Docket: NRC-2013-0070

Application and Amendment to Facility Operating License Involving Proposed No Significant Hazards Consideration Determination; San Onofre Nuclear Generating Station, Unit 2

Problem Statement: Two Independent Nuclear Experts (Dr. Joram Hopenfeld and an Anonymous SONGS Insider) certify that MHI SG Tube Fatigue and Stress Calculations Assumptions are erroneous and based on faulty data – NRC is legally required to certify MHI's calculations to assure that San Onofre Unit 2 does not pose significant radiological risks at 70% normal steady state power operations during Anticipated Operational Transients and Design Basis Accidents.

Fig-2 Wear Pattern 2

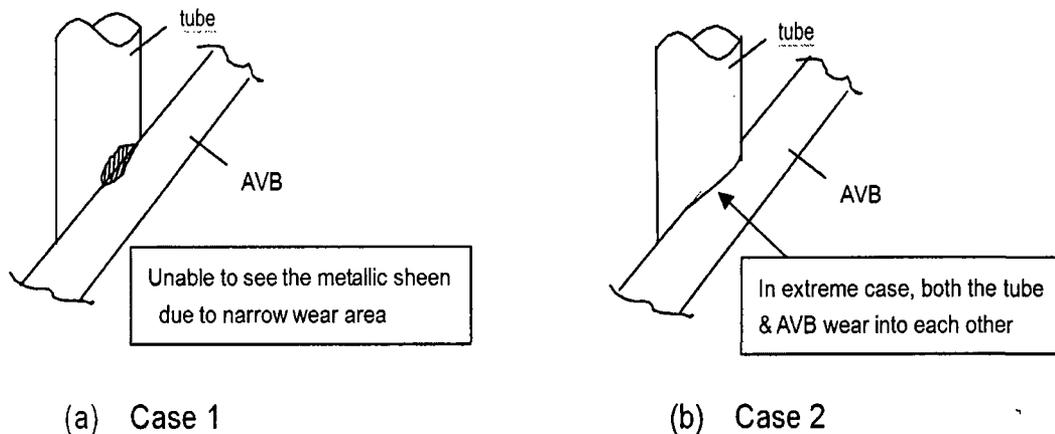
A. In Unit 2 Return to Service Report, Attachment 4, MHI Documents SO23-617-1-M1538, Revision 0, page 288 of 474, Appendix 7, L5-04GA564(9), page 7-9, Figure 2, MHI states, "Section 3.2, Wear Pattern-2 (Local Wear on Tube Surface Characteristics):

- (1) Local wear occurs on the tube but the wear surface is not exposed (cannot be seen),
- (2) Unable to determine if wear occurs on tube or AVB or both,
- (3) Unable to determine the direction of motion or vibration, and
- (4) An extreme interpretation is that both tube and AVB are worn into each other.

As depicted in the MHI drawings above (Figure 2), the support bar and the tube form a sharp discontinuity at the contacting surface, therefore the appropriate geometry for calculating the stress concentration is an abrupt geometry change (very small radii or zero radii of a notch in accordance with RG 1.121), not a large radius shoulder fillet that was assumed by MHI. When a correction is made to account for the sharp notch, the corrected stress indicates (See Figure 1 above) that the tubes have used up their fatigue life during the first cycle of operation. Structures with sharp notches can fail catastrophically when subjected to high cycle fluid elastic instability and flow-induced random vibrations. (MHI redacted their assumption so the exact value of the radius they used is unknown.)

FIG 1 – COMPARISON OF THE MHI CALCULATED STRESS WITH THE STRESS CALCULATED IN THE CPUC REPORT

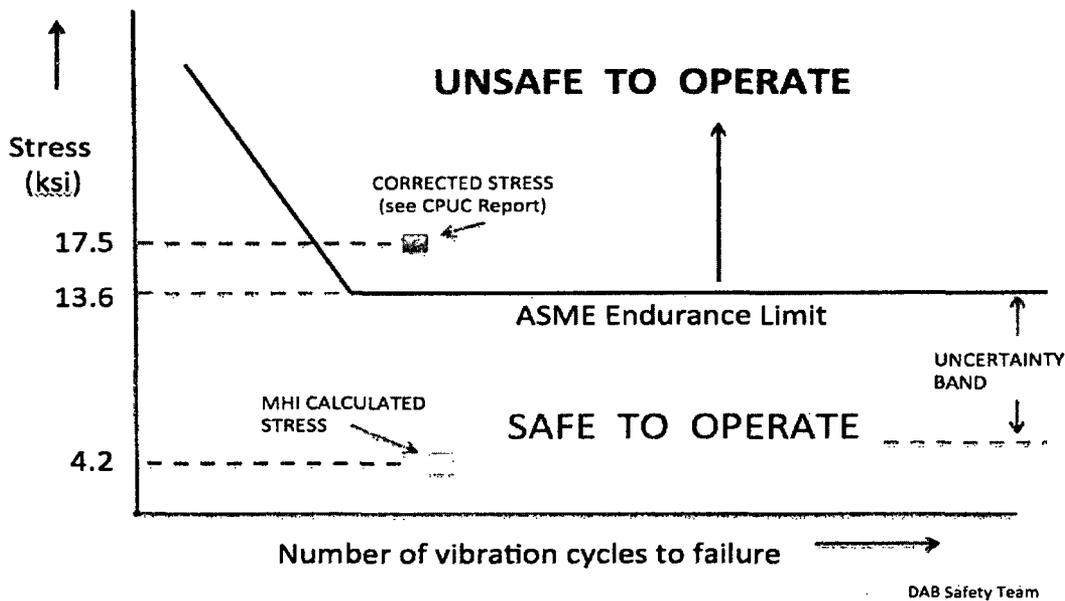
C. The source of MHI's error described below resulted from how they calculated the increase in the local stress at geometrical discontinuities (notches), which are formed when two metal surfaces come in contact during vibration. Since the worn surfaces of the tubes inside the steam generators as described above cannot be seen, MHI made two incorrect key assumptions, which are inconsistent with the observation that both the tube and the supporting bar are worn into each other. First, MHI assumed that the ASME endurance limit could be applied directly to the notched tube surfaces. Since it is commonly known that surface roughness significantly reduces fatigue life and since the ASME data is for smooth polished surfaces, this assumption would underestimate the amount of fatigue damage. Second, when using the Peterson chart, MHI assumed an unrealistically large fillet radius and consequently derived a low concentration stress factor. Large radii would decrease the local stress and cause the tube to fail at a higher level of stress, thereby increasing its fatigue life. Only by using these two, arbitrary, non-conservative-assumptions was MHI able to conclude that Unit 2 did not suffer any fatigue damage.

Fig. 6-4 Wear shape of tube at the contact point with AVB

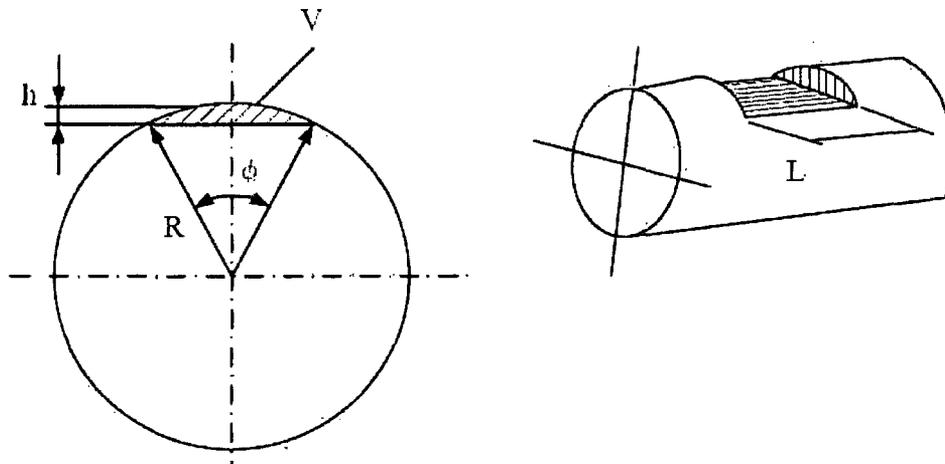
- (Page 10-2, Section 2) "Conclusion: When consecutive 6 or 8 AVB support points are inactive and in-plane FEI does not occur, the calculated tube wears at AVB support points due to only the turbulent flow force are equivalent to the wear depths measured in Unit-2 SGs."
- (Page 10-20, Item (7) "Wear Calculation: Experimental correlations between the metal loss and the work rate are used to calculate tube metal volume reduction. The relation between wear volume (V) and wear depth (h) is represented as follows: (a) Tube to AVB wear and Tube-to-Tube wear: The tube thickness reduction is then calculated using the wear properties and work rate parameter as assuming the wear configuration as shown in Fig.6-4. The wear width of tube to AVB wear is assumed to be the same as the width of AVB.

Note: Both the impact and the sliding motions play a part in the tube/AVB interaction. These factors reduce tube strength because of material loss and loss of fatigue strength.
